6.1 Ministerial Planning Referral - TPMR-2025-21 - 400 Queen Street, Melbourne**Report Author:** Lachlan Orr, Principal Urban Planner**Report Presenter:** Nick McLennan, Acting Head of Statutory Planning**Executive Leader:** Evan Counsel, General Manager Strategy, Planning and Climate**Executive Summary**

**Ministerial application for Planning Permit PA2503754 –
Demolition of the existing building, construction of a
building and a reduction in the bicycle facilities
requirements**

Melbourne City Council reference	TPMR-2025-21
Department of Transport and Planning reference	PA2503754
Address	400 Queen Street, Melbourne
Applicant	Sime Darby Property (Queen Street) Development Pty Ltd
Owner	Kim Lim Aust. Pty Ltd
Architect	Cox Architecture
Proposal	Demolition of the existing building, construction of a building and a reduction in the bicycle facilities requirements
Approximate cost of development	\$495,619,040
Planning controls	Capital City Zone, Schedule 1 Design and Development Overlay, Schedule 1 Design and Development Overlay, Schedule 10 Parking Overlay, Schedule 1
Permit requirements	Demolition and to construct a building or construct or carry out works in the Capital City Zone,

Figure 12 – Northern easement and proposed connection to Anthony Street (Source: Application, dated June 2025, bottom photo from Google, dated May 2022, showing previous gate and top photo Planning Officer, dated November 2025, showing current conditions)

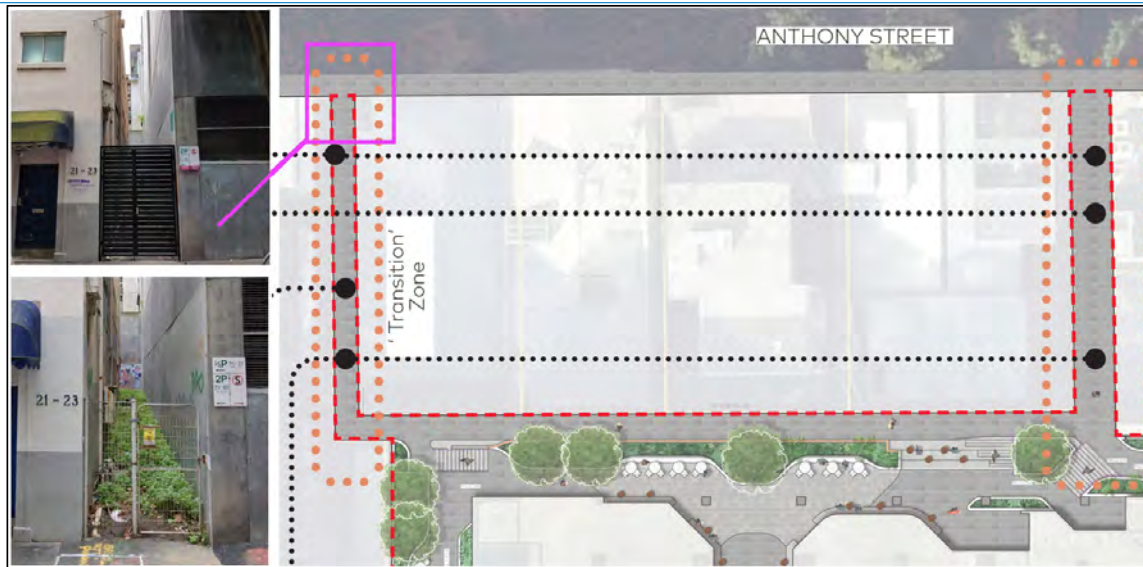
However, there is concern with the north-eastern connection to Anthony Street, which utilises the existing 1.83 metre wide drainage and sewerage easement situated between the blank walls of neighbouring buildings and to be accessed internally via a narrow, steep staircase. It is noted that this easement (E1 on CP161945Q) does not confer any rights of carriageway to others. There is concern with the lack of passive surveillance to this space and the potential for entrapment due to its long, narrow dimensions and lack of any active frontages. There is also no significant need for a pedestrian connection in this location, noting the layout of the existing pedestrian network as well as the classification of Anthony Street as a class 2 lane under Clause 15.01-1L-01 (CBD Lanes). The site is located on a block which is not identified as having an average length of more than 100 metres on Map 1 to the Appendix of the *Central Melbourne Design Guide*. The layout of this space is an existing condition constrained by neighbouring development and, given the safety and entrapment risks, it is not considered appropriate to convert it to a publicly accessible space. A recommended condition will require the redesign of this space to restrict access to the public.

- A recommended condition will require the northern easement area to be restricted from public access, which will alleviate potential safety and entrapment risks in this narrow, enclosed space. Otherwise, the revised layout of steps, landscaping and retaining walls provide a more suitable pedestrian experience within the publicly accessible areas and will enable adequate sight lines and integration with the public realm.

Figure 16 – Extract of indicative material schedule (Source: Applicant dated June 2025)

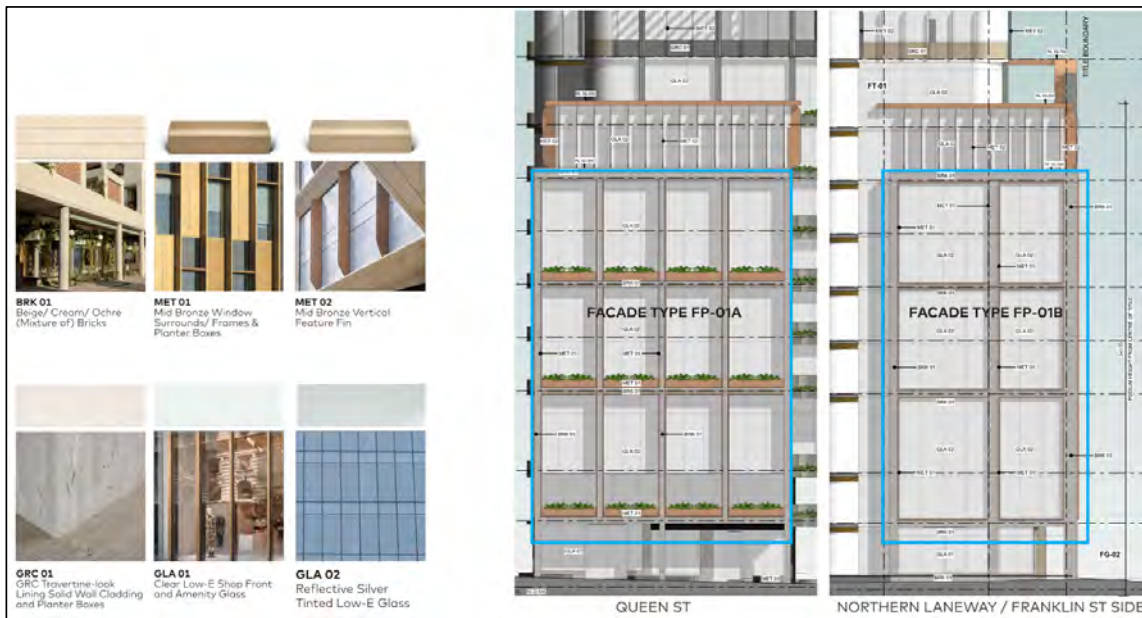
A condition requiring the endorsement of a façade strategy is included in the recommendation, which will also address a recommendation from City Design relating to the variation in depth on the northern podium. Standard conditions will also require the endorsement and implementation of a Reflective Glare Assessment, which will ensure the building materials are designed to comply with *Practice Note PPN96: Glare and reflectivity*.

Figure 21 – Student unit S-3B with retractable privacy curtains and S-2A with no living room windows (Source: Applicant, September 2025)

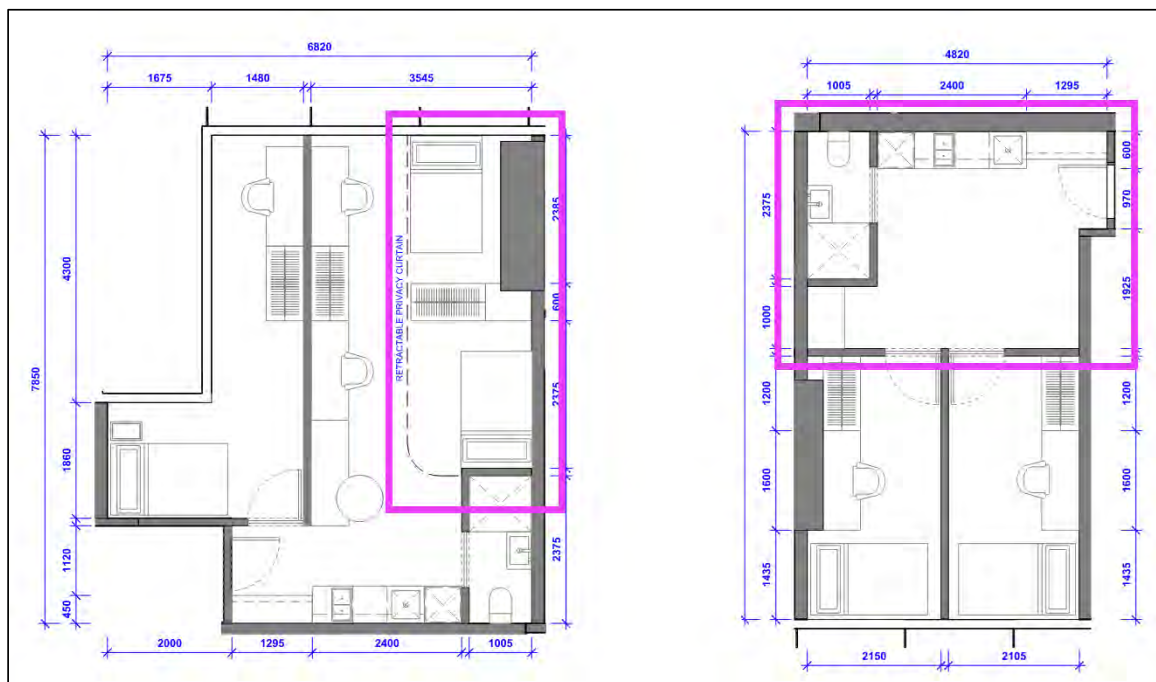
- One of the 3-bedroom cluster types S-3B includes two beds located in the same room shared with the kitchen and dining area, separated by retractable privacy curtains. There is also a two-bedroom cluster type S-2A which does not provide any windows to its shared living space, which will provide poor amenity for future occupants. See figure 20 below. These are not considered to be acceptable arrangements for the amenity of future occupants within a new building. A recommended condition will require all beds to be located in individual rooms, and all living spaces to be provided with access to daylight.

Figure 22 – Communal open space areas on levels 7 and 8 (Source: Applicant, September 2025)

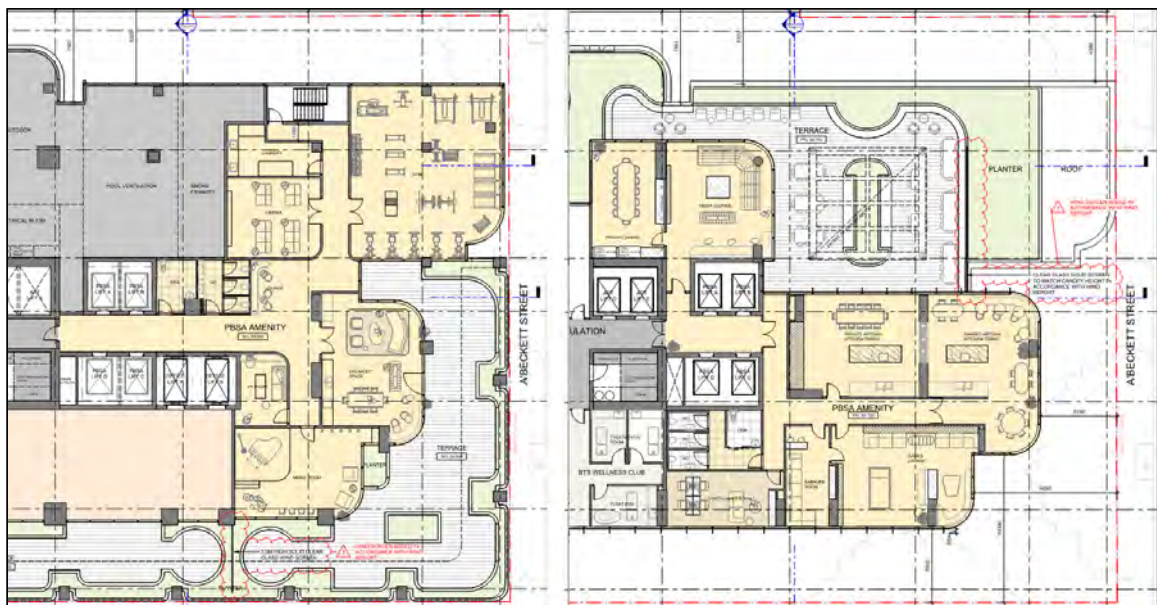
- While the total student numbers may be affected by recommended conditions detailed above, this would result in a reduced number of students and therefore would not result in any further non-compliance with the policy requirements for communal areas.

Figure 23 – Extract from Landscape Concept Plan showing proposed planting in response to Standard D10 (Source: Applicant, June 2025)

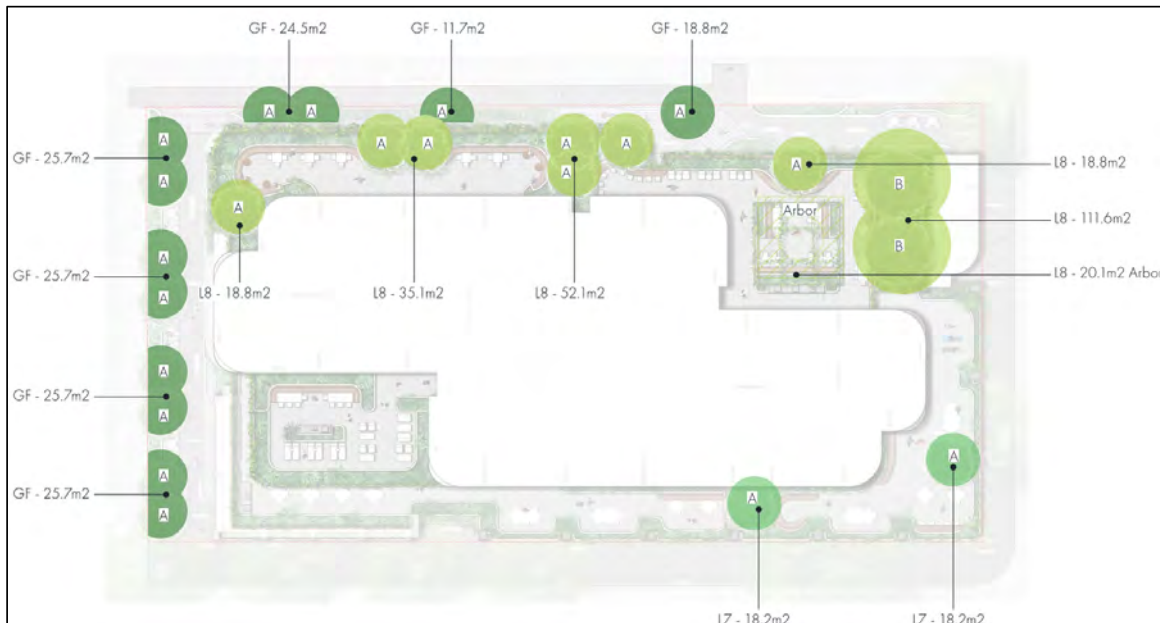
- The shortfall of canopy coverage is relatively minor having regard to the landscape character of the area and does not prevent the development from achieving increased canopy cover as sought by this clause.
- The proposal provides several tree plantings along the publicly accessible areas and communal terraces. The spaces include integrated landscaping which enhances and improves legibility within both the public spaces and internal amenities for building occupants.
- The street edges to Queen Street and A'Beckett Street will incorporate planter boxes, contributing additional greening to the public realm.
- The proposal achieves a Green Factor score of 0.59, exceeding the minimum score of 0.55, which further demonstrates adequate landscaping can be incorporated throughout the building.

Figure 24 – Extract of Apartment type A01.1 (Source: Applicant, September 2025)

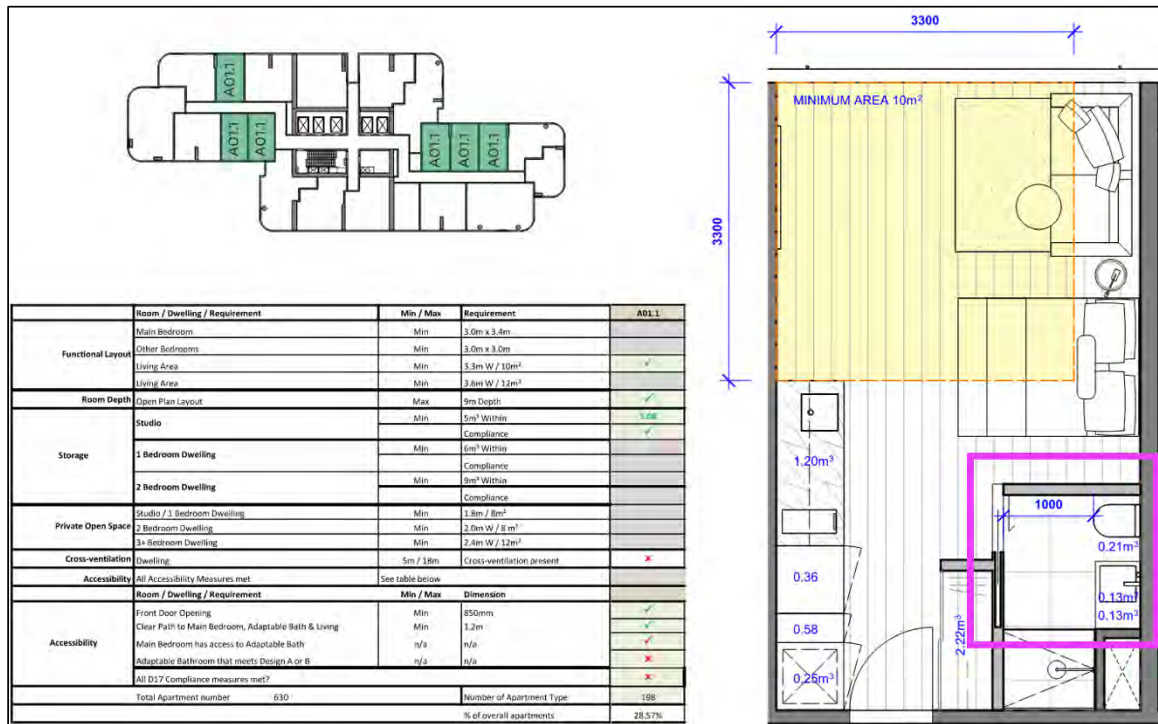
A condition is included in the recommendation to ensure at least 50% of dwellings are designed to comply with Standard D18. It is anticipated that this could be achieved by modifying studio apartment type A01.1, which accounts for 198 or 28.57% of the total apartments, to include a bathroom that meets the design requirements of Table D7.

Figure 25 – Extract of Apartment type A04.1 with variation highlighted (Source: Applicant, September 2025)

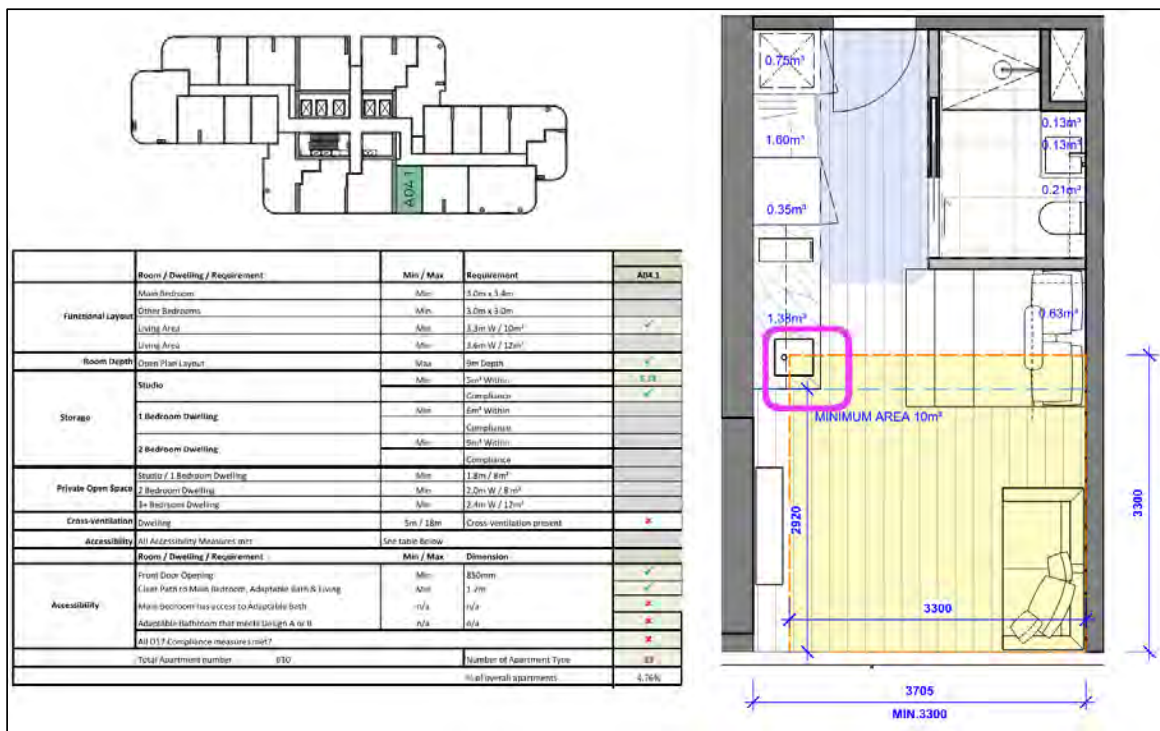
The proposal generally provides living areas and bedroom sizes which comply with the requirements of Standard D26, with the exception of studio apartment type A04.1 which does not provide the required internal living room dimensions and widths specified in Table D12. The variation is associated with a section of the kitchen bench / sink area which encroaches into the 10 square metre area required for the living area.

- The proposed variations are relatively minor, in the order of approximately 300 mm deep and 0.15 square metres in area.
- The shape, layout and integration with the remainder of the apartment area will achieve a functional space overall.
- The layout of the apartments otherwise satisfies the internal amenity standards of Clause 58 such as room depth, windows and natural ventilation.
